**Submission from the Maules Creek
Community Council (MCCC)**

**Maules Creek Coal Mine
Continuation Project**

Project Application Number: SSD-63428218

4.8.2025

Fig1: Green Gully GW967138.1.1 (top in red) has fallen 1 meter compared to nearly 4 meters at Middle Creek South Well (bottom in blue) since it peaked on August 24 2022. Note that the differences in scale on the y axis

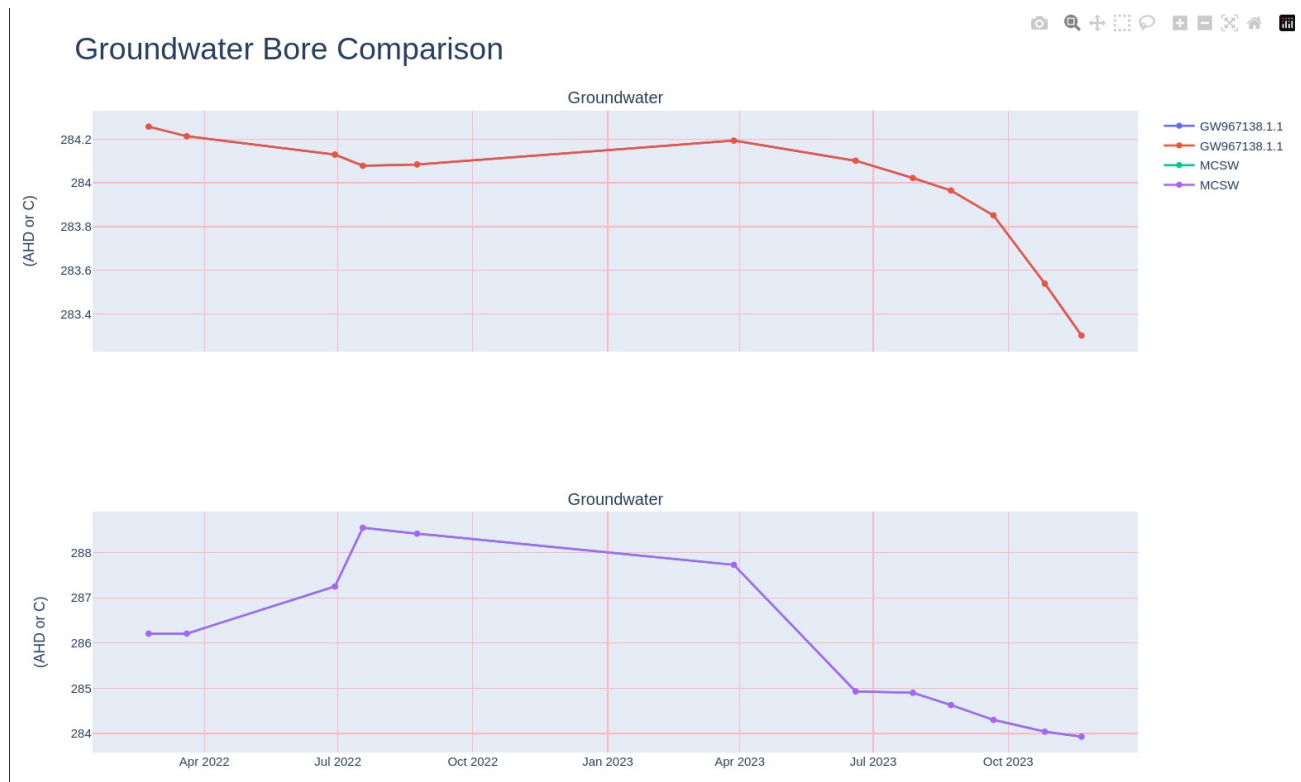
Fig 1: Green Gully groundwater monitoring station compared to Middle Creek South Well
